From: [Jason Duffey](#)
To: [Case, Rachel L](#); [Cameron, Susan](#)
Cc: [Josh Henry](#); [Jennifer Broush](#); chris@batgate.com
Subject: Transco SSE - May 16, 2025 USFWS Meeting Minutes
Date: Friday, May 23, 2025 1:09:00 PM
Attachments: [image001.png](#)
[Transco SSE May 16, 2025 USFWS Meeting - Notes.pdf](#)

VA and NC USFWS Meeting Agenda

Transco Southeast Supply Enhancement Project

Figure 1. Conservation sites and predicted suitable habitat within the project area.

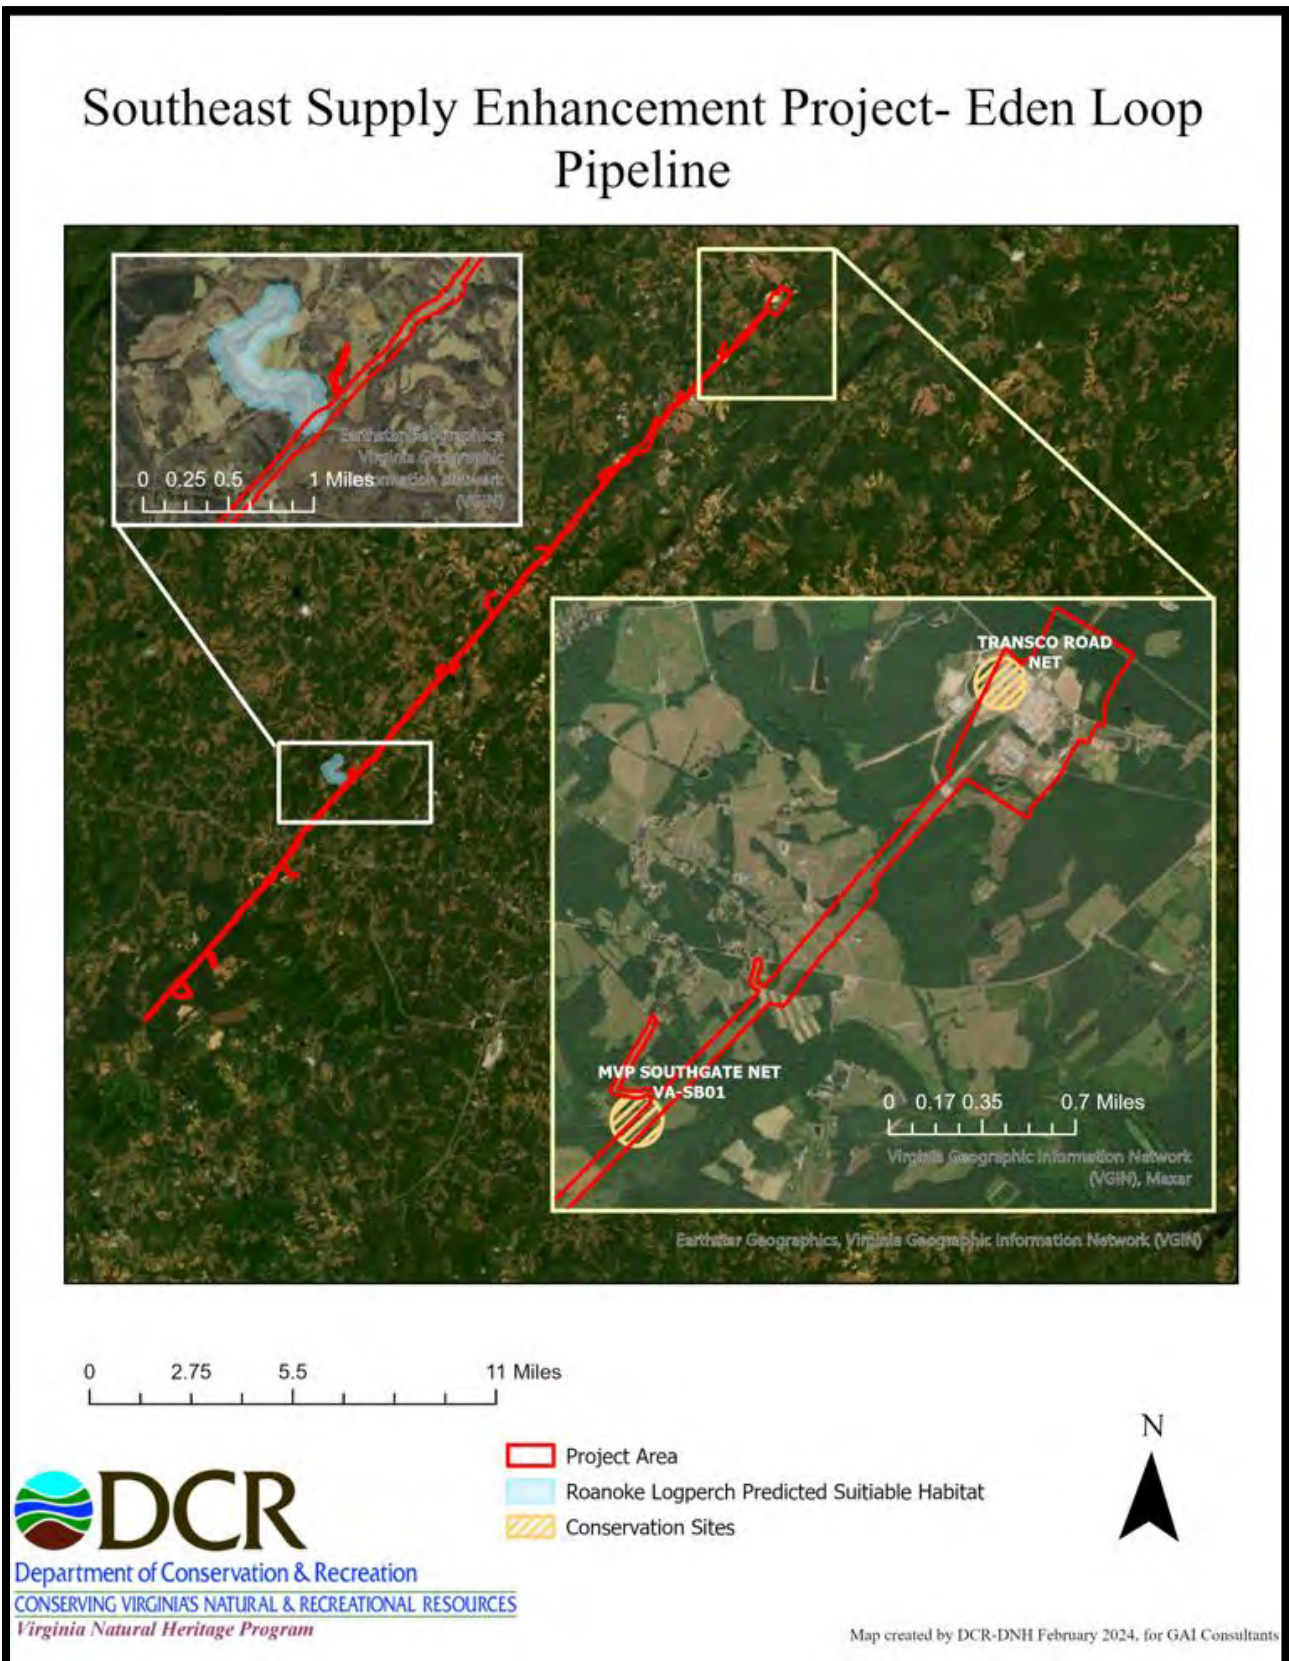
According to the information in our files, the Transco Road Net Conservation Site and the MVP Southgate Net VA-SB01CA Conservation Site are both located within the project area (Figure 1). Conservation sites are tools for representing key areas of the landscape that warrant further review for possible conservation action because of the natural heritage resources and habitat they support. Conservation sites are polygons built around one or more rare plant, animal, or natural community designed to include the element and, where possible, its associated habitat, and buffer or other adjacent land thought necessary for the element's conservation. Conservation sites are given a biodiversity significance ranking (B-rank) based on the rarity, quality, and number of element occurrences they contain; on a scale of 1-5, 1 being most significant. The Transco Road Net Conservation Site and the MVP Southgate Net VA-SB01CA have both been assigned a B-rank of B4, which represents a site of moderate significance. The natural heritage resource associated with both sites is:

According to DCR's predicted suitable habitat modeling and review by a DCR biologist, there is a potential for Roanoke Logperch (*Percina rex*, G1G2/S1S2/LE/LE) to occur where the project crosses the Sandy River if suitable habitat exists on site (Figure 1). The Roanoke Logperch is endemic to the Roanoke and Chowan River drainages in Virginia (Burkhead and Jenkins, 1991) and inhabits medium and large, warm, and usually clear rivers with sandy to boulder spotted bottoms (NatureServe, 2009). Please note that this species is classified as endangered by the United States Fish and Wildlife Service (USFWS) and the Virginia Department of Wildlife Resources (VDWR).
